Access Compliance Report

Public Rights-of-Way

Intersection ID: 16132	Main Street: S_TRYON_ST	Cross Street: W_CAMA_ST	Location: NW
ADA ID: 6102926FC193	Ramp Type: PerpDiag	Initial Pass/Fail: Fail	Overall Compliance: No
Severity Score: 10			
Codes/Mitigation Info/Possible Solution		Field Measurements/Component Compliance

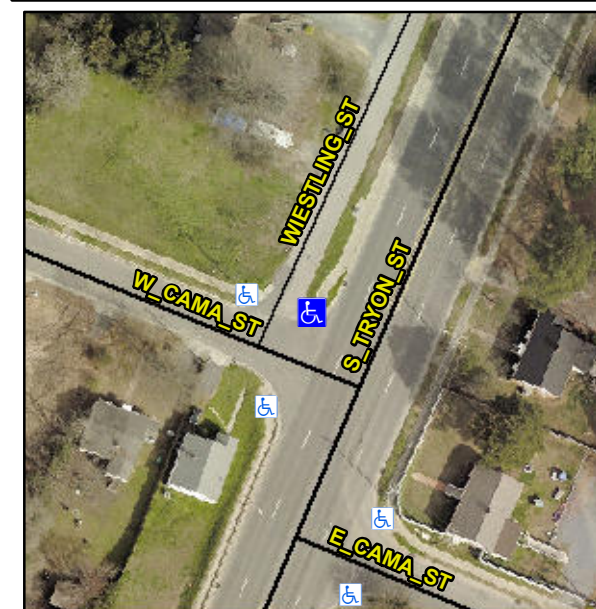
R304.5.1, R304.5.3

Compliance	Description	Data	Compliance	Description	Data
N/A	Ramp Length (in)	69.0	Yes	Ramp Slope (%)	5.8
No	Ramp Width (in)	47.0	No	Ramp XSlope (%)	2.6
N/A	Flare Type LT	N/A	N/A	Flare Type RT	N/A
N/A	Flare Slope LT (%)	N/A	N/A	Flare Slope RT (%)	N/A
N/A	Flare Traversable LT?	N/A	N/A	Flare Traversable RT?	N/A
N/A	Landing Length (in)	N/A	N/A	DWS Provided?	N/A
N/A	Landing Width (in)	N/A	N/A	DWS Contrast?	N/A
N/A	Landing Slope (%)	N/A	N/A	DWS Length (in)	N/A
N/A	Landing X Slope (%)	N/A	N/A	DWS Full Width?	N/A
N/A	Landing Curb? (Y/N)	N/A	N/A	DWS Offset (in)	N/A
N/A	Shared Landing?	N/A			
N/A	Gutter Ponding?	N/A	N/A	Gutter Slope (%)	N/A
N/A	Gutter Lip Ht (in)	N/A	N/A	Gutter X Slope (%)	N/A
N/A	Painted X Walk1?	No	N/A	Painted X Walk2?	No
	X Walk 1 Direction	To SW		X Walk 2 Direction	To SE
N/A	X Walk 1 Width (in)	N/A	N/A	X Walk 2 Width (in)	N/A
	X Walk 1 Slope (%)	0.9		X Walk 2 Slope (%)	1.8
	X Walk 1 X Slope (%)	0.1		X Walk 2 X Slope (%)	0.9

Remove & Replace Curb Ramp With Two New Directional Ramps or Equivalent.
